Premier House Manchester, UK — Sustainable Drainage Strategy

CLIENT / Property Alliance Group REV / 01 DATE / 3 August 2022

PROJECT NO / L20081

BG&E Markup
 SR
 19.04.21

Drainage Survey

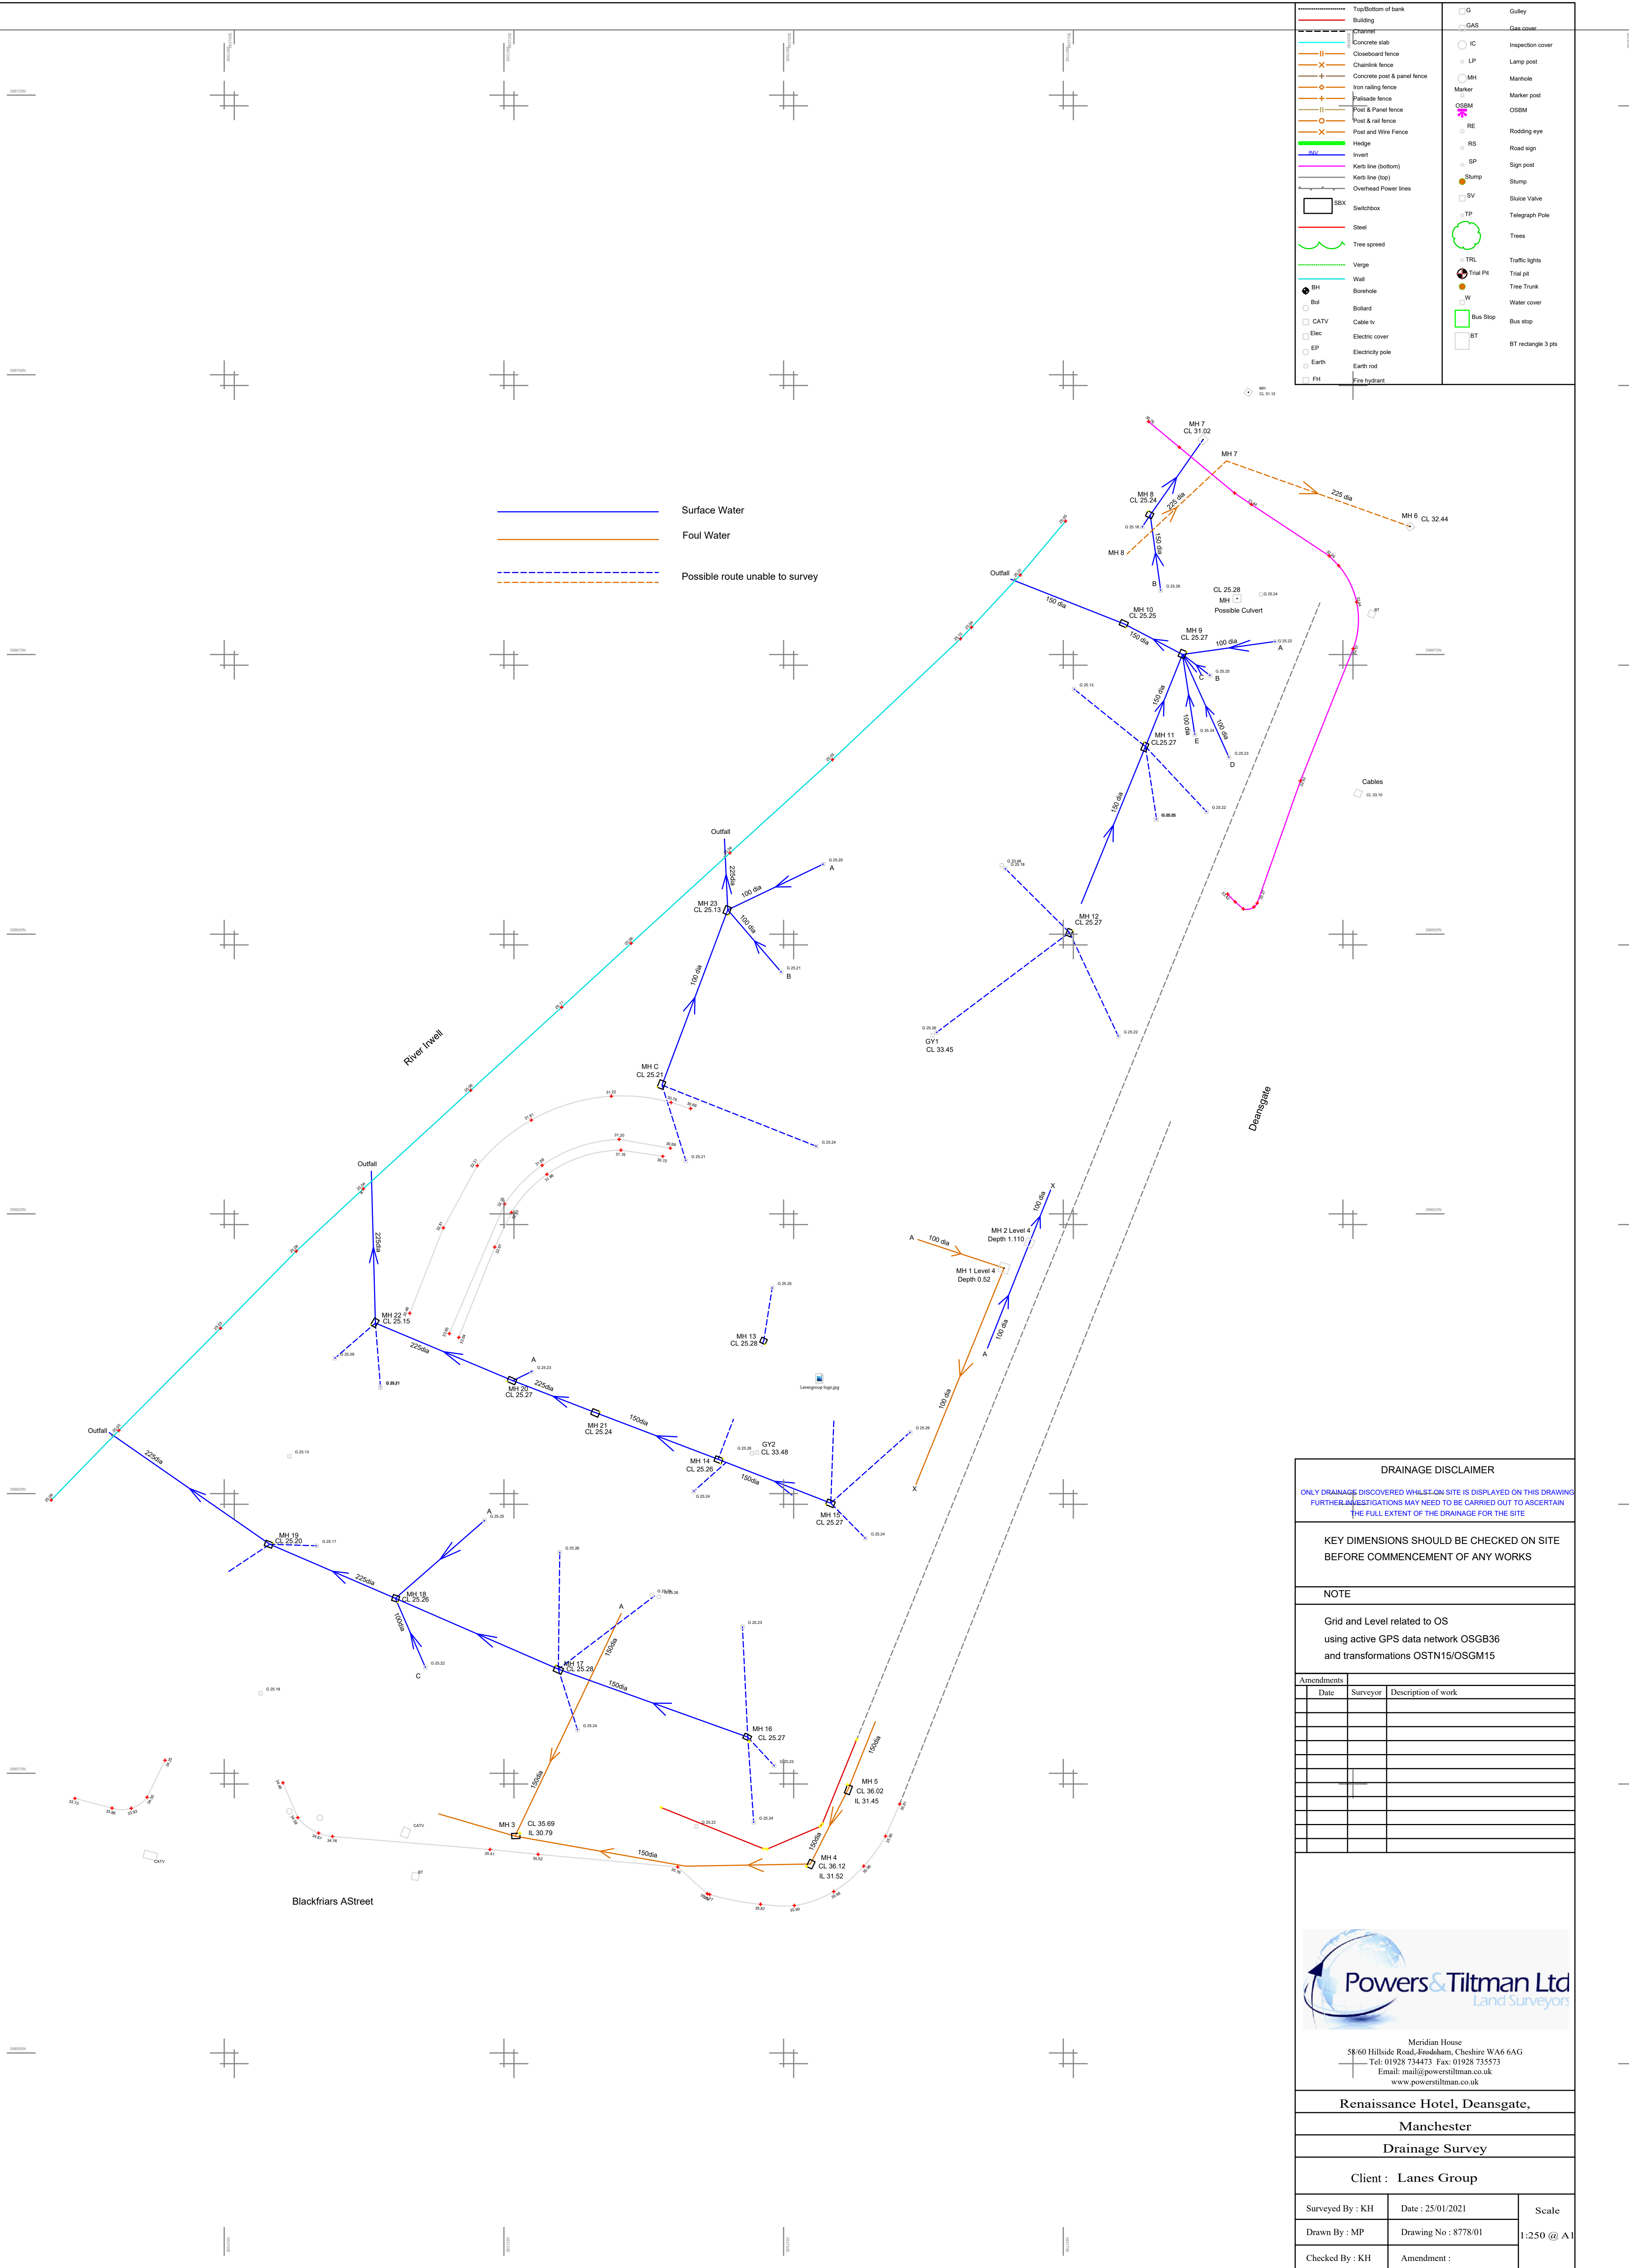
Were these chambers buried?

Was this manhole lifted?

Was this manhole lifted?

Was the public sewer along Deansgate surveyed?

We believe there is drainage in the vaults, under the ramp. Was this within your scope of work and do you have any photographs of this area?

Why does the trace end here?

Why does the trace end here?
